SUNDRY NOTICES AND REPORTS ON WELLS
Do not use this form for proposals to drill or to re-enter an abandoned well. Use Form 3160-3 (APD) for such proposals.

RIDGEWAY ARIZONA OIL CORP.

Proposed Plug & Abandonment Procedure

**Farrell Federal 20
30-041-20696
Ridgeway Arizona Oil Corp
September 5, 2019
Conditions of Approval**

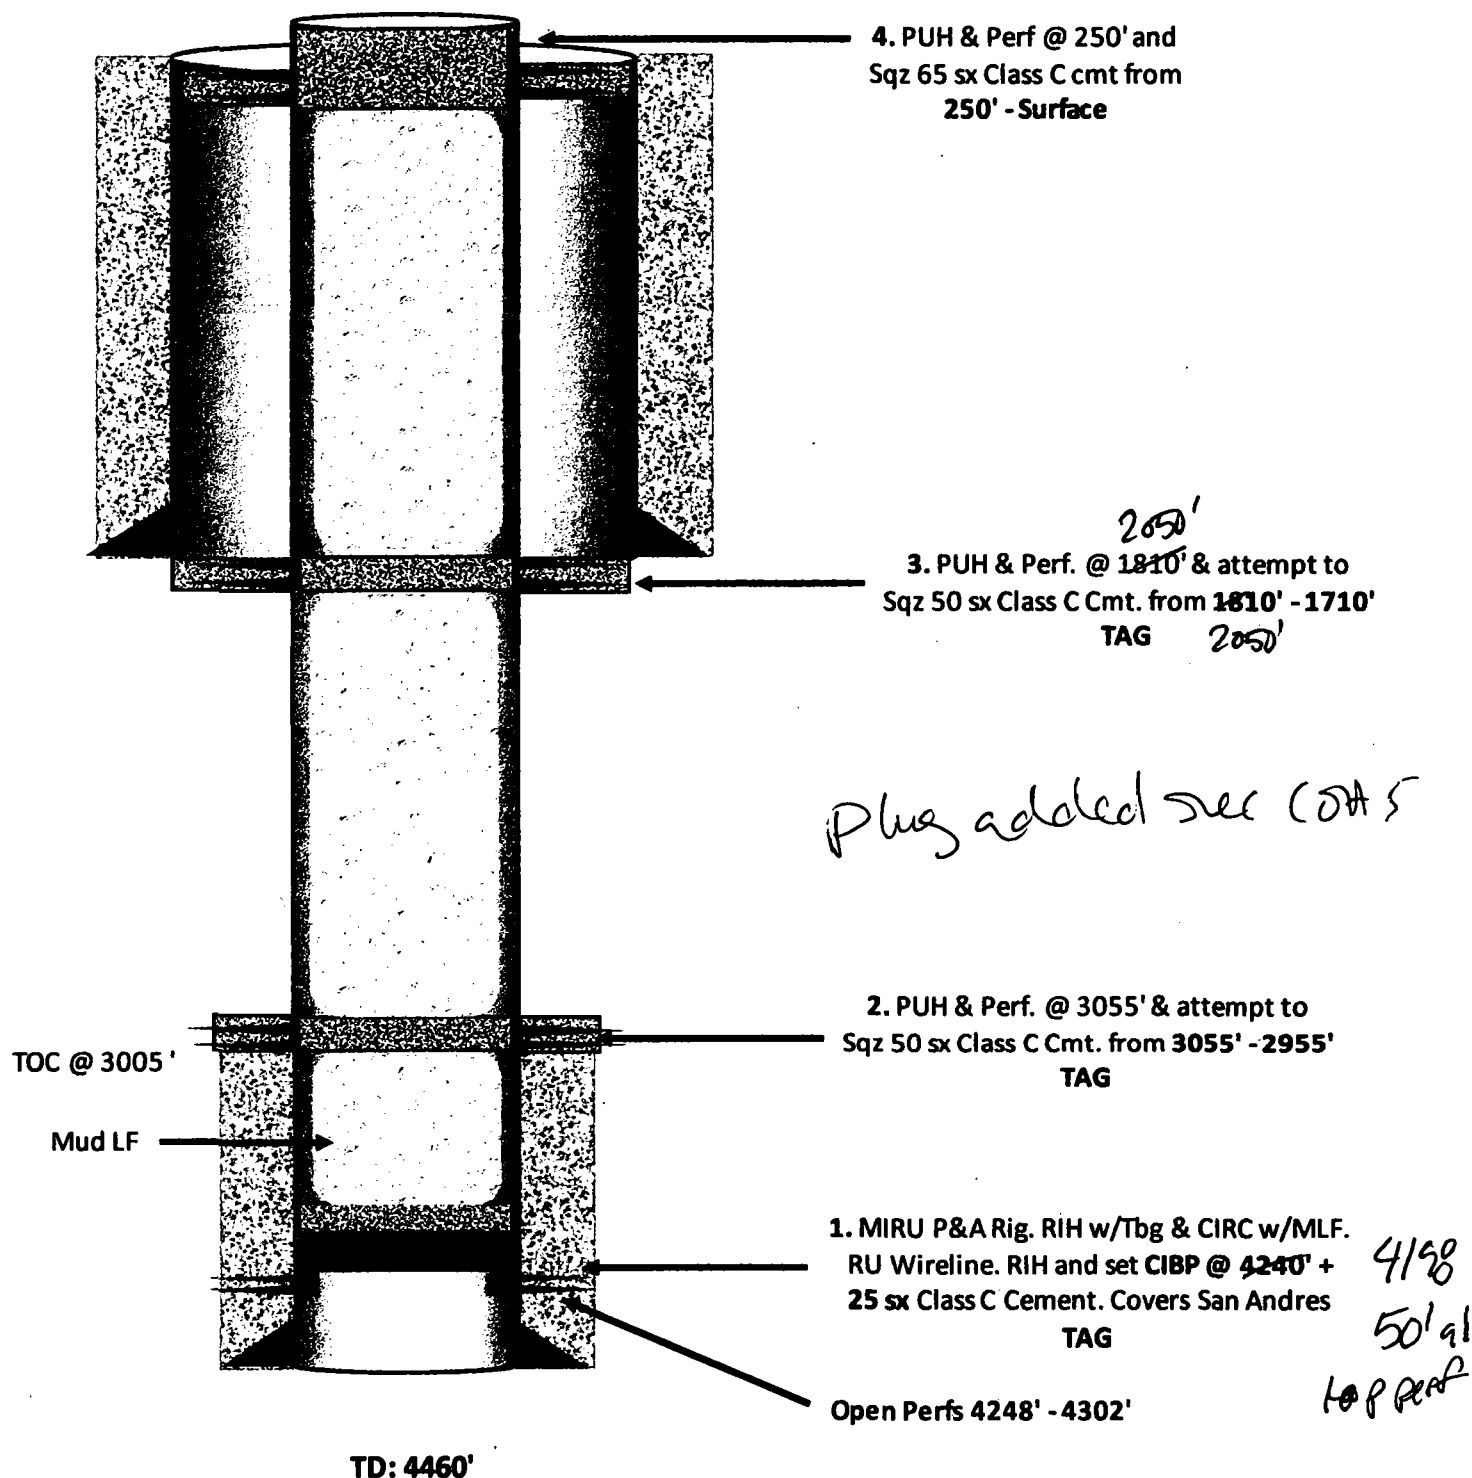
1. Operator shall place CIBP at 4,198' (50'-100' above top most perf) and place 25 sx of Class C cement on top as proposed. WOC and TAG.
2. Operator shall perf and squeeze at 3,055' as proposed. Operator shall place a balanced Class C cement plug from 3,055'-2,955' as proposed. WOC and TAG.
3. Operator shall perf and squeeze at 2,335'. Operator shall place a balanced Class C cement plug from 2,335'-2,210' to seal the Yates Formation and the bottom of the Salt. WOC and TAG.
4. Operator shall perf and squeeze 50 sx of class C cement as proposed at 2,050. Operator shall place a balanced Class C cement plug from 2,050'-1,710' to seal the top of the Salt and the 8-5/8" shoe. WOC and TAG as proposed.
5. Operator shall perf and squeeze at 250' as proposed. Operator shall place a balanced Class C cement plug from 250' to surface.
6. See Attached for general plugging stipulations.
